**AGENDA**  
**Canmore Planning Commission**  
**Canmore Civic Centre – Council Chambers**  
**Wednesday, March 20, 2024**  
**2:00 p.m.**

## STAFF REPORT

<b>DATE:</b>	MARCH 20, 2024
<b>PROPOSED DEVELOPMENT:</b>	COMPREHENSIVELY DESIGNED MULTI-UNIT RESIDENTIAL DEVELOPMENT (18-UNIT STACKED TOWNHOUSE)
<b>APPLICATION NUMBER:</b>	PL20230389
<b>LEGAL DESCRIPTION:</b>	LOT 29, BLOCK 21, PLAN 231 690
<b>CIVIC ADDRESS:</b>	205 STEWART CREEK RISE
<b>CURRENT USE(S):</b>	VACANT LAND
<b>APPLICANT:</b>	CANMORE COMMUNITY HOUSING
<b>REFERENCED DOCUMENTS:</b>	LAND USE BYLAW 2018-22: <ul style="list-style-type: none"><li>• SECTION 3.21 R2A-SC DISTRICT</li><li>• SECTION 11 COMMUNITY ARCHITECTURAL &amp; URBAN DESIGN STANDARDS</li><li>• SECTION 12. DENSITY BONUS REGULATIONS</li></ul>

ELEVATIONS

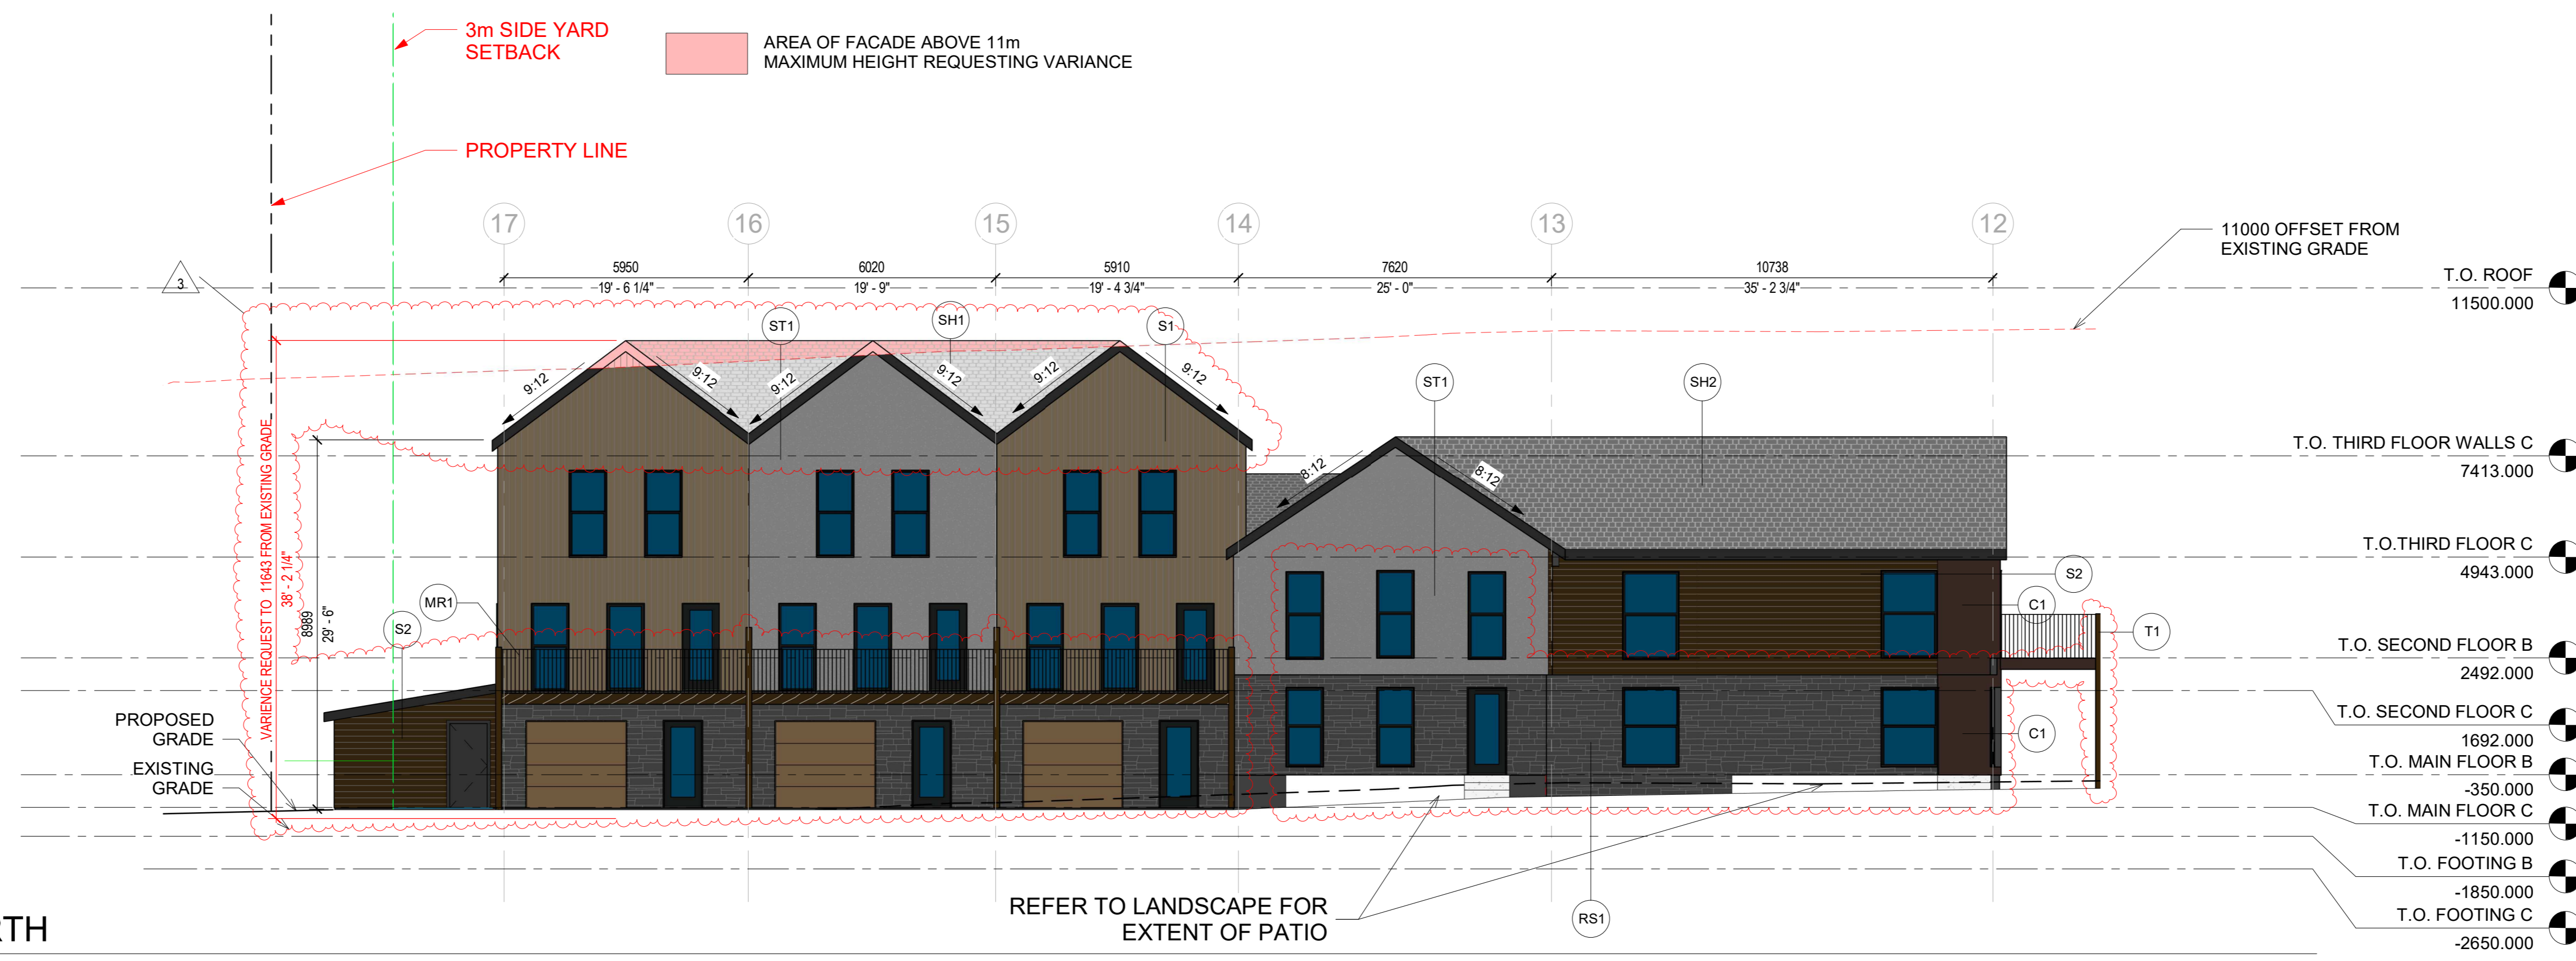
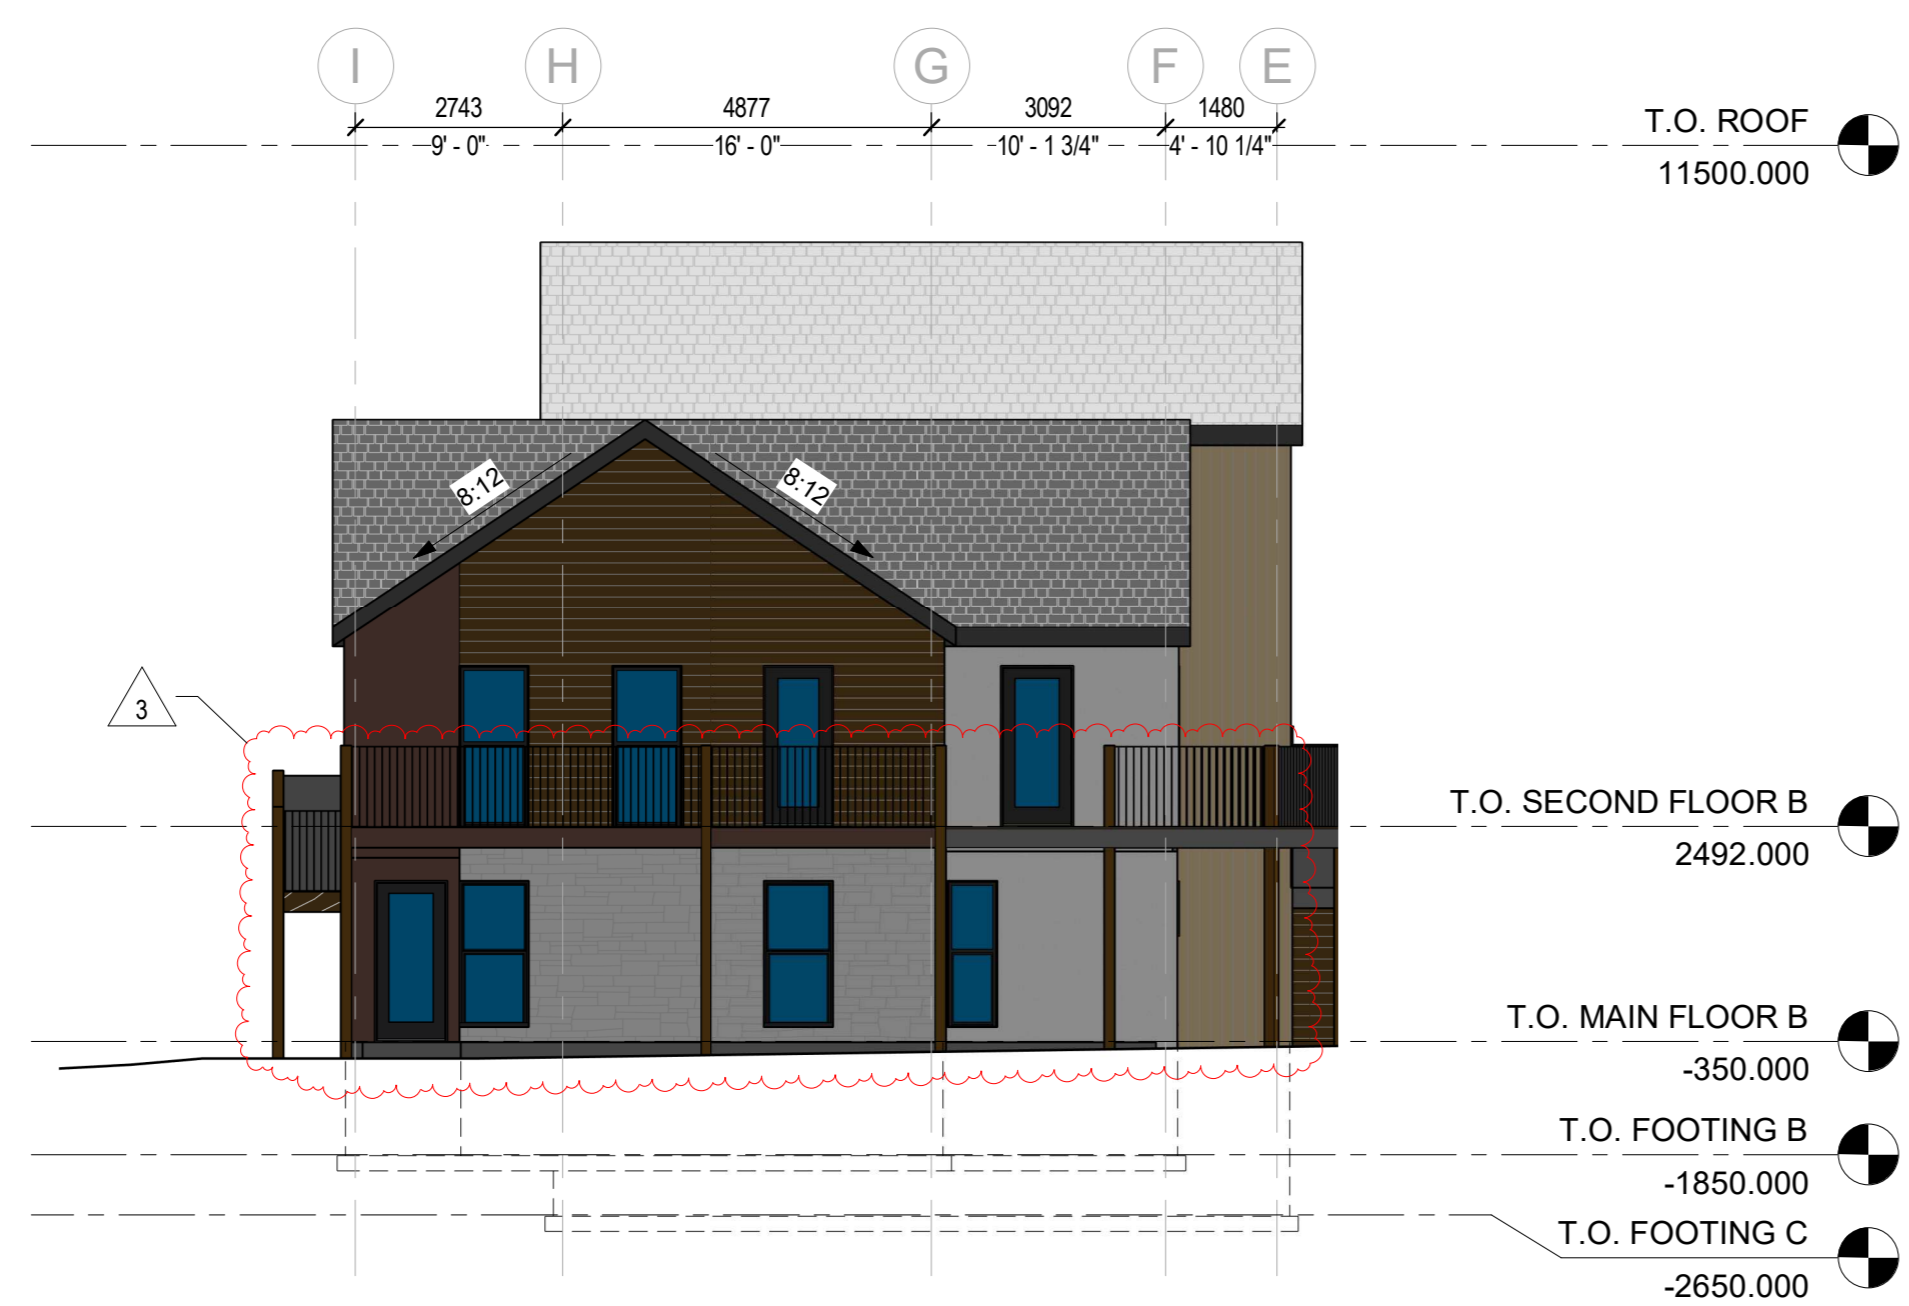
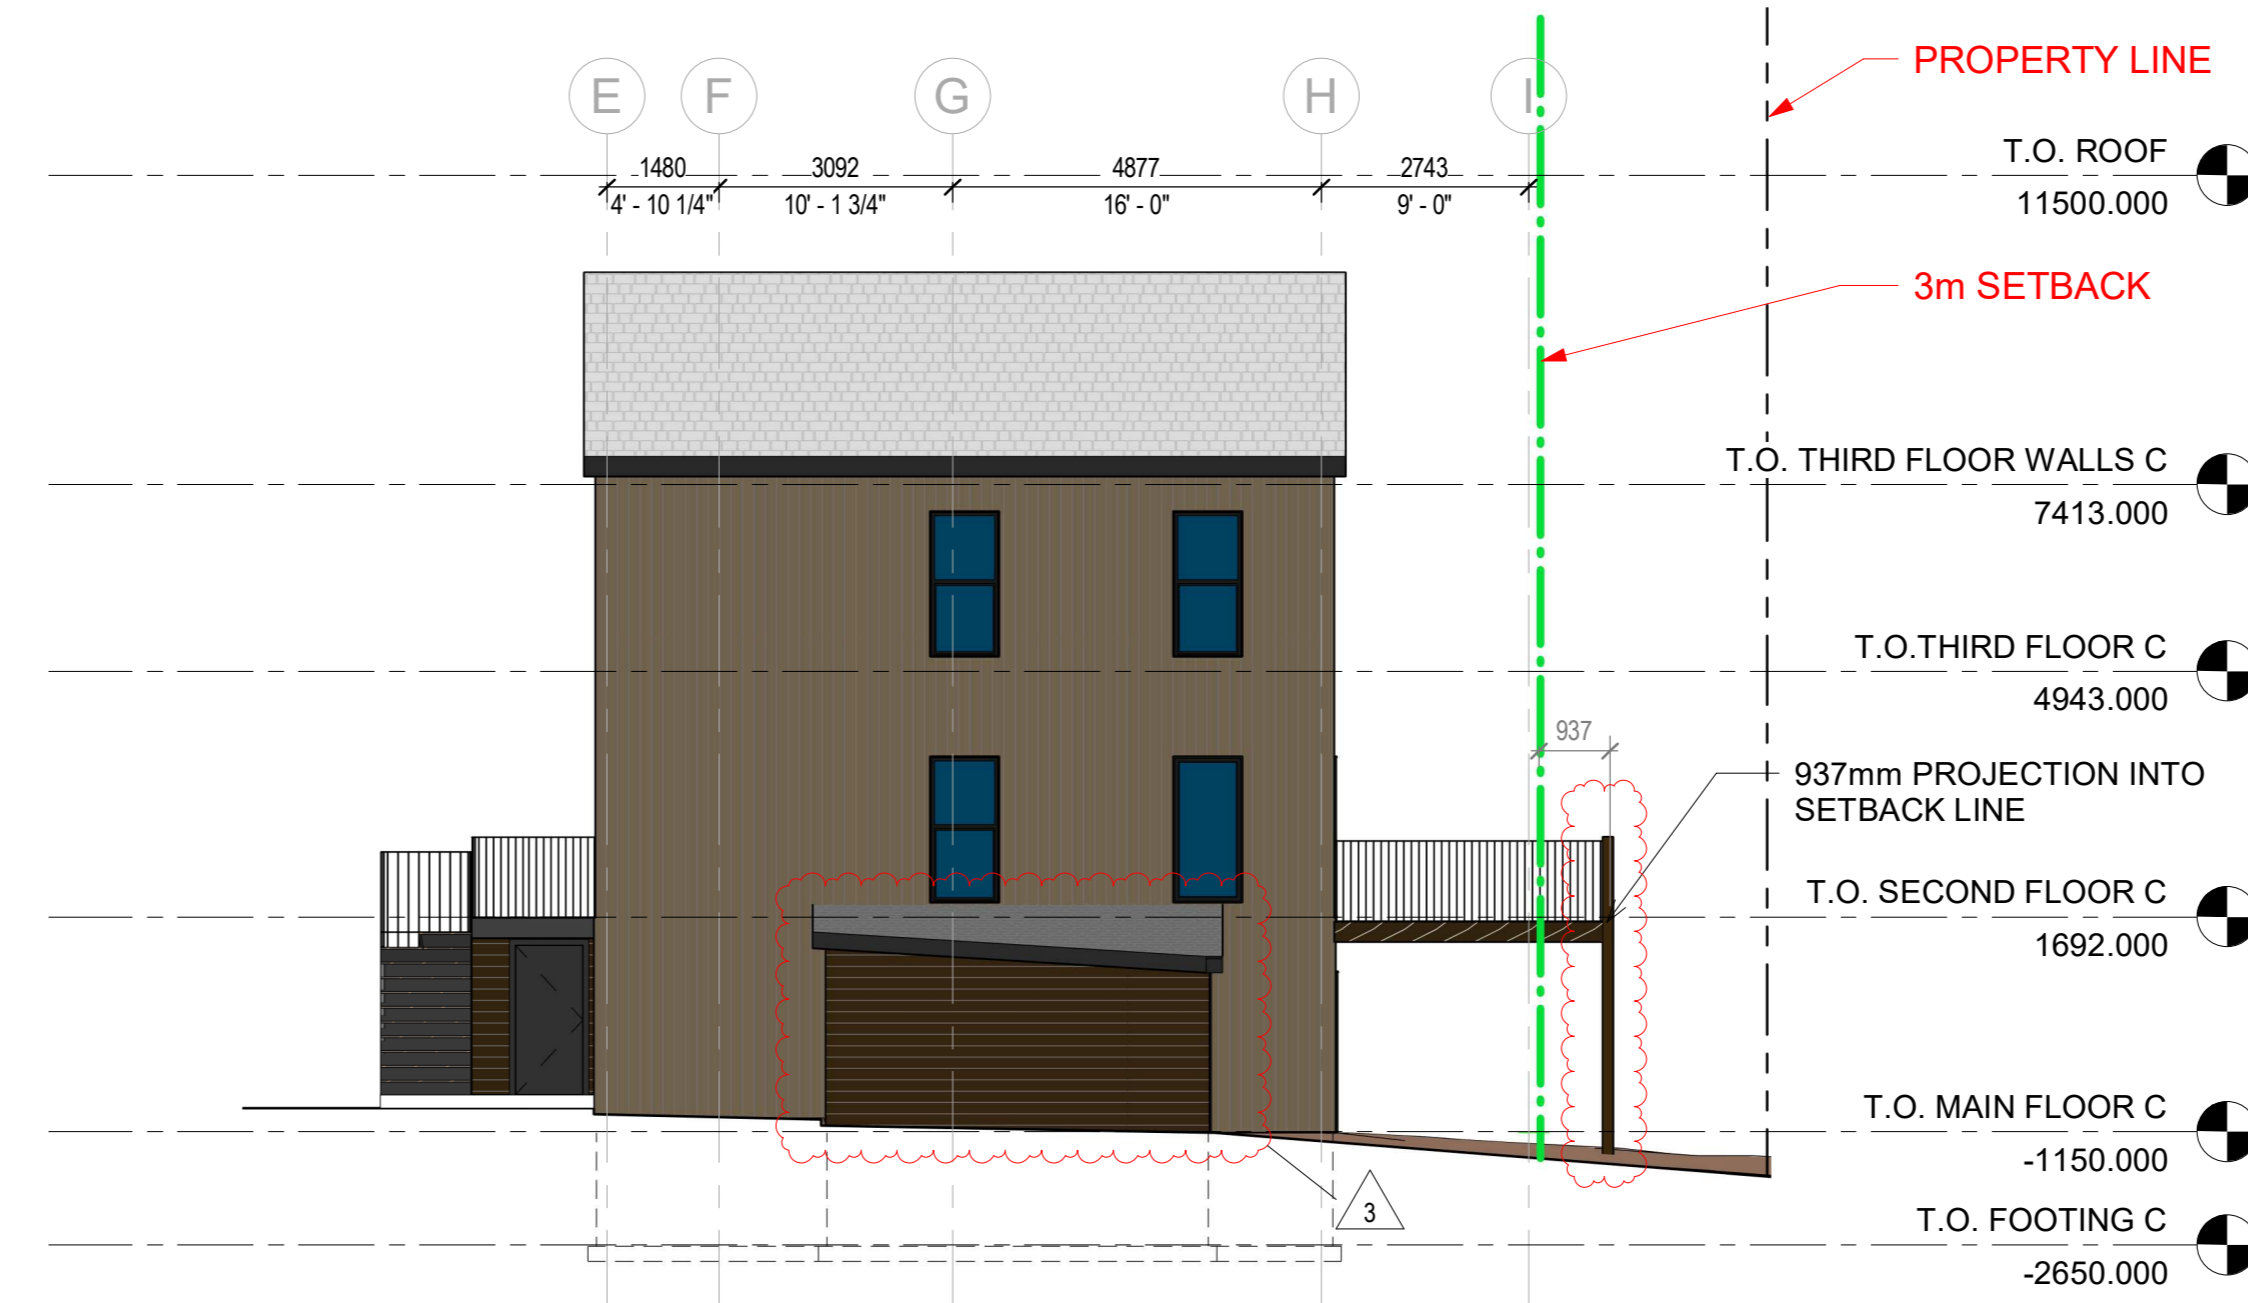
The proposed development is 11.67 m in height, requiring a 11.2% variance (see Figure 2 and 3).

With regards to impacts on adjacent developments, the development does not appear to unreasonably impact the access to views, privacy, or light of the adjacent properties. For example, the buildings step up as they move from their sides to their middle, which makes its impact on the east and west developments the same as, or even less than, a compliant building built to maximum height right to the setback (see Figures 2 and 3). Furthermore, there is 15 m of distance between the property line of this site and the adjacent site to the north. In addition, there is 26 m of separation between the rear property line of this site and the façade of the townhomes (excluding the garages) to the south. Finally, there are roof areas for both buildings that are substantially under height, which is to the advantage of the adjacent properties to the north and south.
